SK#03
04 pages
Date: 04-25-2025

1250 Maryland Avenue
1250 MARYLAND AVENUE SW
WASHINGTON, DC 20024

DRAWING TITLE
STEEL DETAILS

10 TYPICAL SCREEN WALL DETAIL
SCALE: 3/4" = 1'-0"

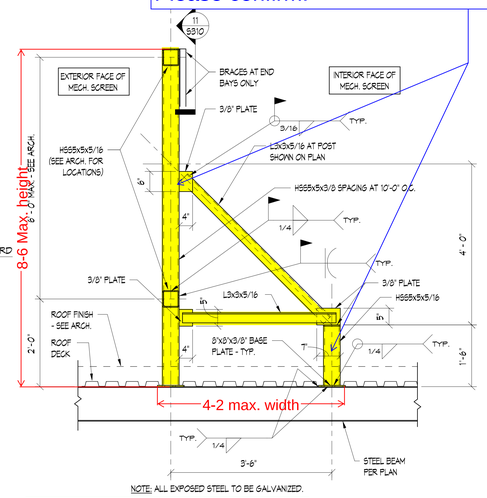
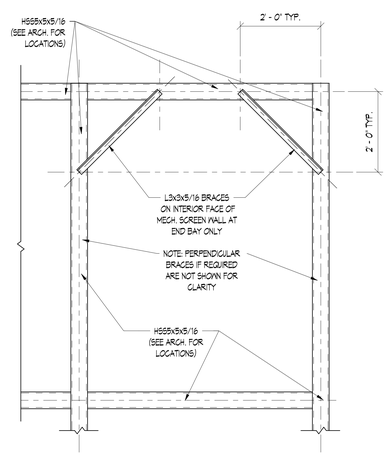
Q1

We intend to make the screen wall steel at yellow highlighted area as one GALVANIZED frame.(see frame height xwidth marked in red)

Please confirm.

SNAP FROM 10 & 11/S310

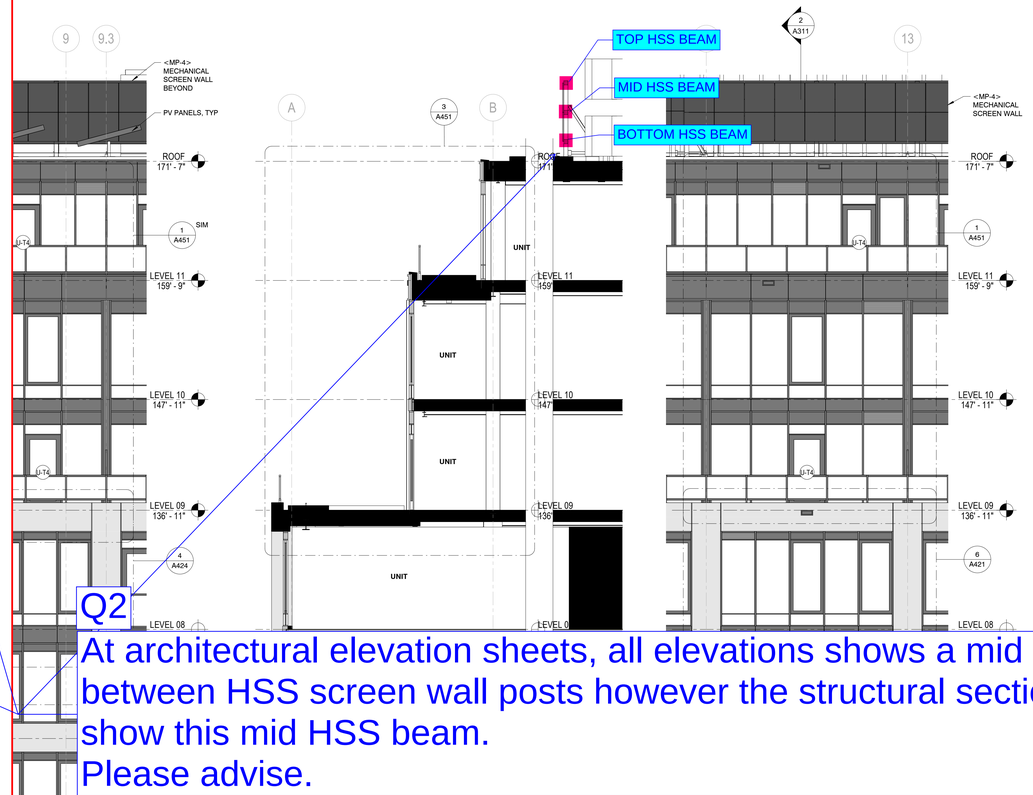
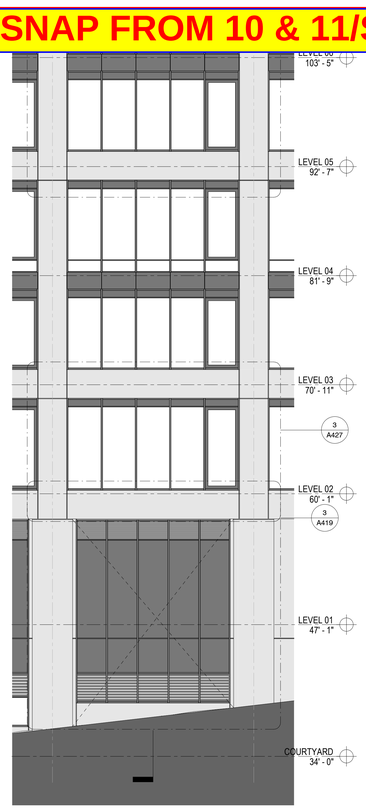
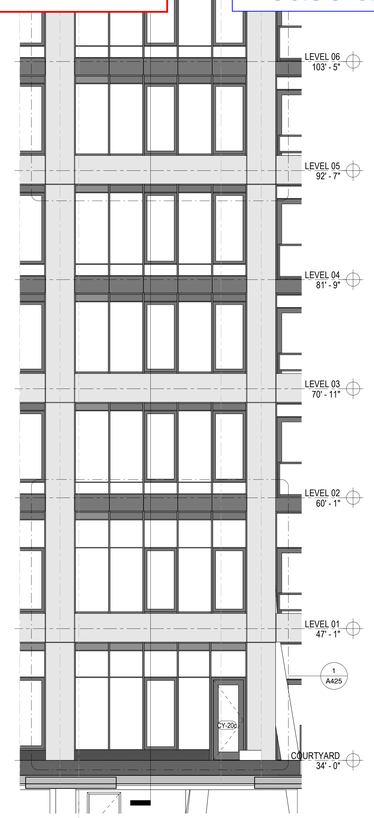
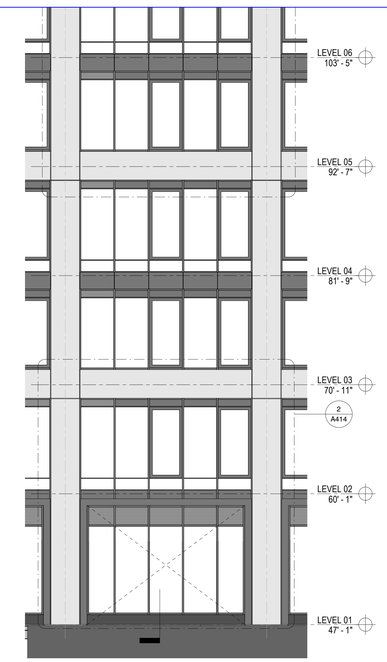
At architectural elevation sheets, all elevations shows a mid HSS run between HSS screen wall posts however the structural sections do not show this mid HSS beam.
Please advise.

SNAP FROM 10 & 11/S310

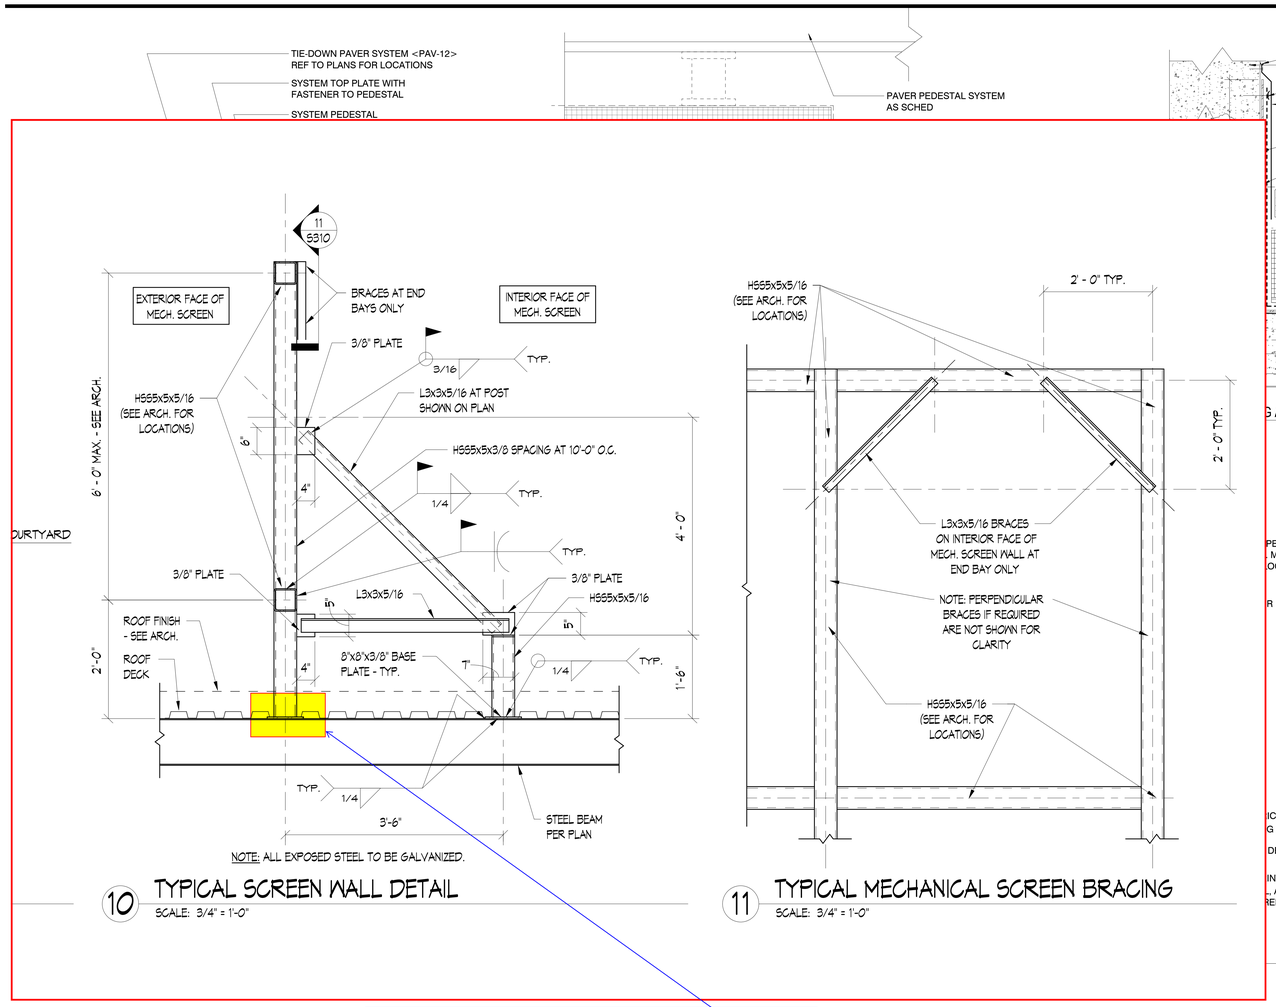
Architectural section 2/A571 shows an additional stub post at the screen wall post's bottom connection(highlighted in magenta)but structural section 10/S310 shows a single post directly welded to the roof beam's top flange. Please review and advise.

DETAIL-01
SNAP FROM MODEL

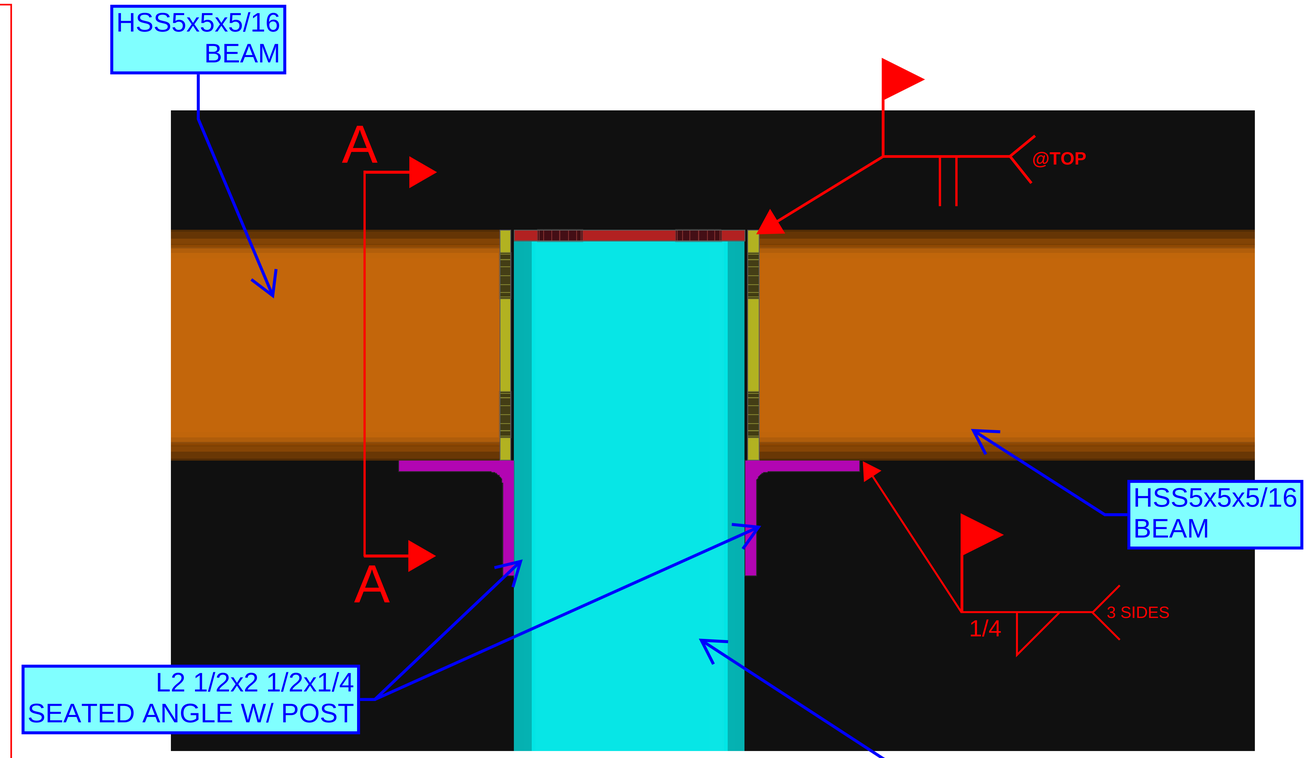
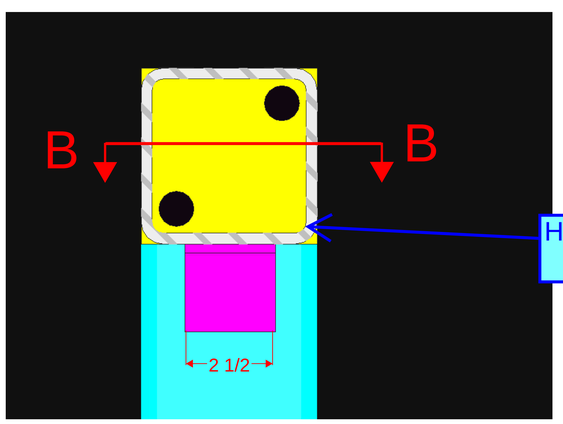
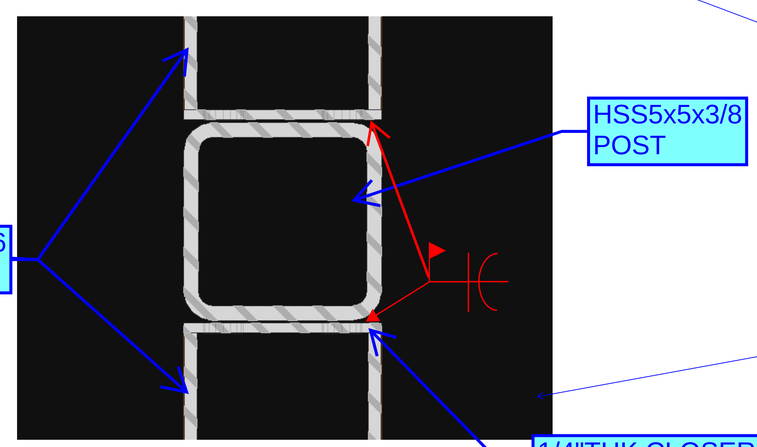
Q4
PLEASE REVIEW SCREEN WALL HSS BEAM TO HSS POST CONNECTION DETAILS SHOWN DETAIL#1 ARE OK TO PROCEED?
